POWER PLANT - ENGINE - REROUTE THE CORE HARNESS TO ENSURE ADEQUATE CLEARANCE BETWEEN THE HARNESS AND VARIOUS TUBES - CATEGORY CODE 6 - MOD.ENG-71-0120

V2500-ENG-71-0120

SERVICE BULLETIN

Location of clip points 5788, 5789 and 5790
Fig.1

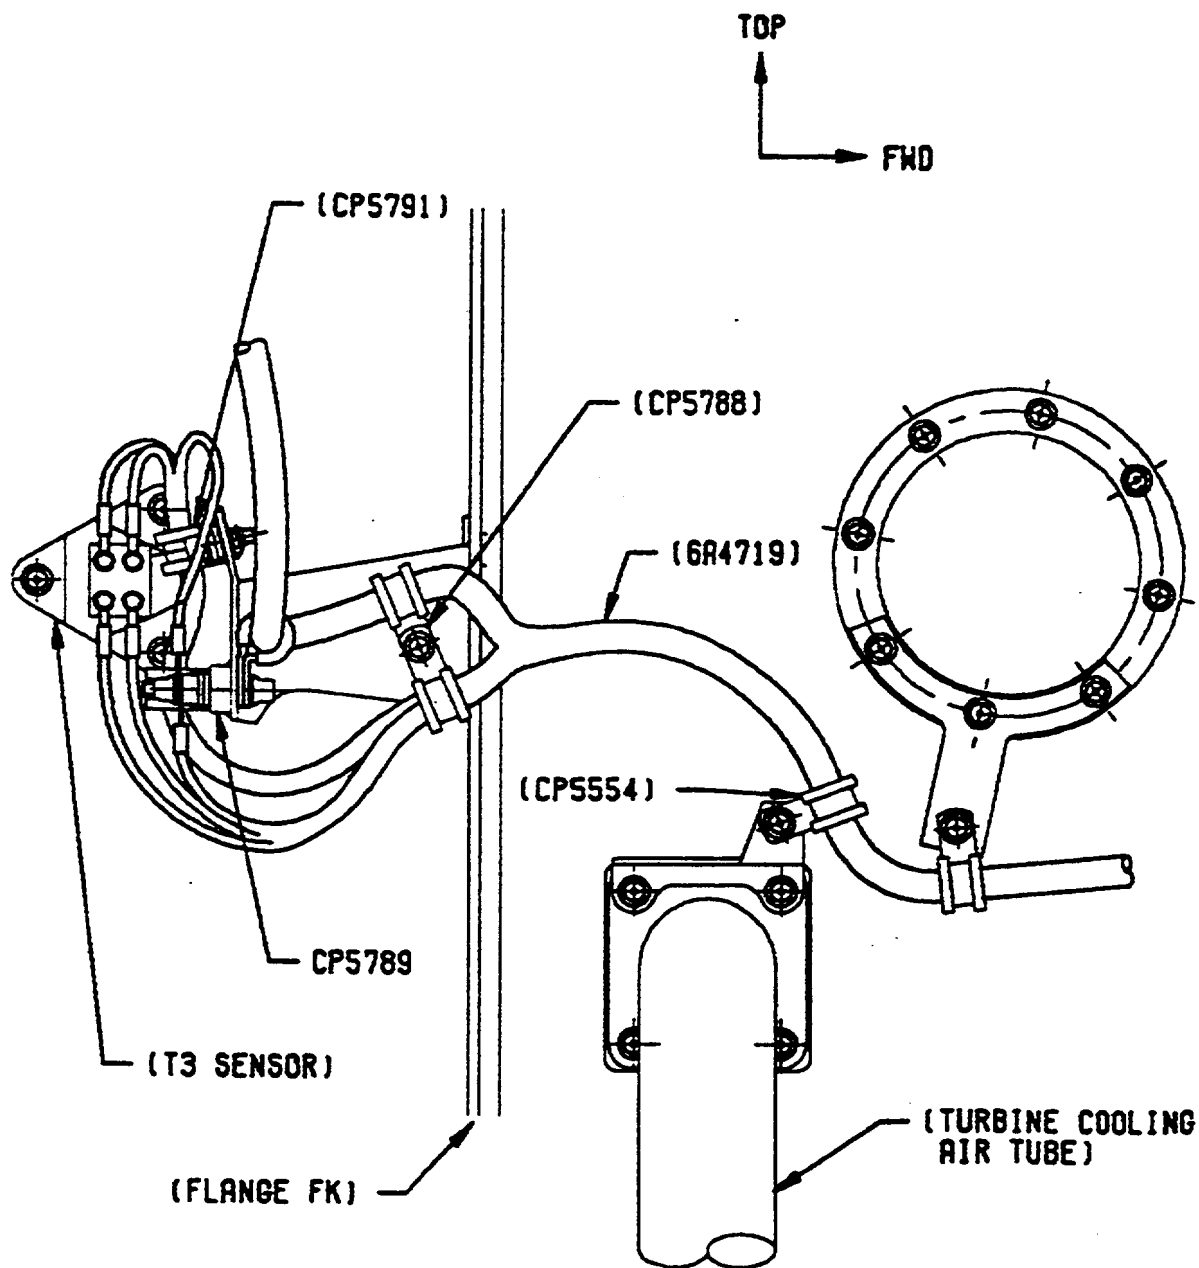
- (a) Clip point 5790 is deleted and the lead clipped at this point has been incorporated into Clip Point 5789 to provide improved clearance with the adjacent fuel manifold tube.
- (b) A clip and spacer are added to Clip Point 5789. The spacer has been added to lift the earthing tags away from the bracket and prevent damage to the tags during tightening of the securing bolt.
- (c) Clip Point 5788 remains unchanged but the harness leads in each clip are transposed to create a greater clearance with the R.H.S. air supply tube from the stage 10 make-up valve.

- (1) Disassemble clipping point 5790. Discard the bolt, the washer and the nut, but keep the TA0210046FT04 or ST1455-04 clip. Refer to Figure 1 and Figure 4.

- (2) Disassemble clipping point 5789. Discard the 4W0105 bolt but keep the remaining parts. Refer to Figure 2 and Figure 3.
- (3) Disassemble clipping point 5788 sufficiently to remove the two limbs of the 6A4719 harness. Move the two harness limbs so that they go into the opposite clips. Assemble clipping point 5788 with the 6A4719 harness limbs in their new positions using the existing clipping point components. Refer to Figure 1 and Figure 2.
